# Memorandum

Date: September 5, 2024

Re: **Traffic Engineering Review #3**  
**Proposed Warehouse Development**  
**1525 Wood Avenue**  
**Wilson Borough, Northampton County, Pennsylvania**

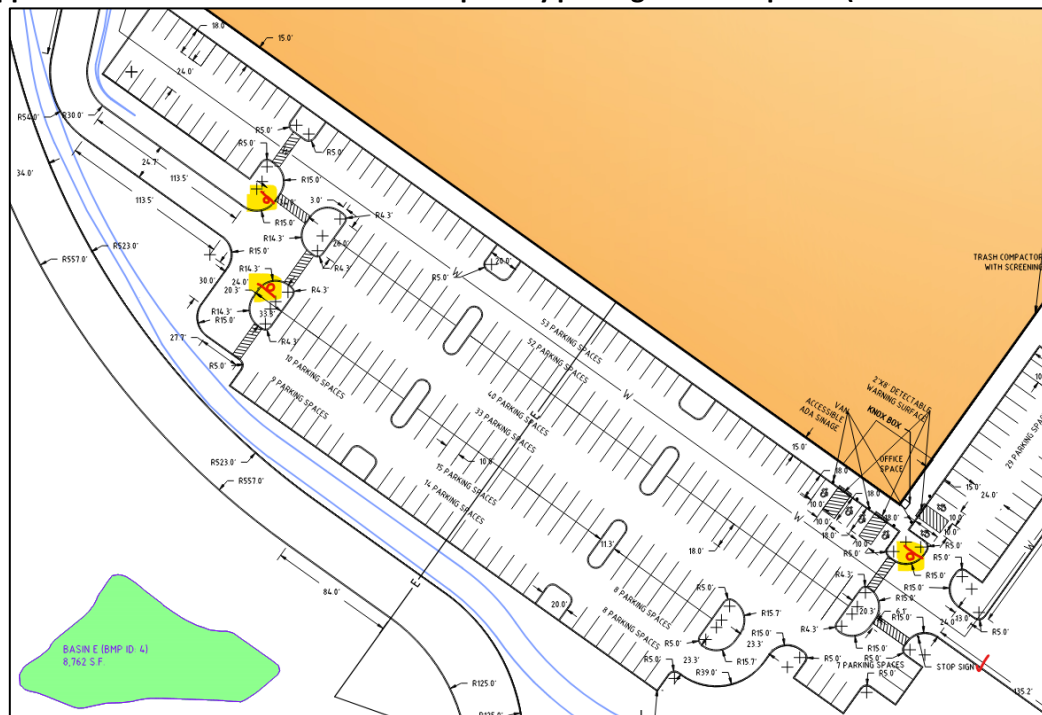
19. Internal drive aisle widths, parking space dimensions, and loading area dimensions, shall be periodically labeled throughout the Site Plans.

**Partially addressed. Additional dimensions have been provided however several drive aisle widths, specifically in the southern parking lot area, vary between 23.3' and 24.7'. The Site Plans shall be revised to show consistent, whole number parking lot drive aisle widths.**

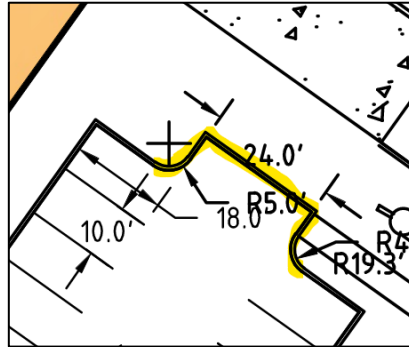
20. R1-1 "STOP" signs and stop bars shall be installed at all proposed Site Driveway approaches which intersect with the public street network.

**Partially addressed.** Specific to the southern parking lot, stop signs shall be provided at all parking lots aisle approaches which intersect with the two primary parking lot access points (see sketch below).
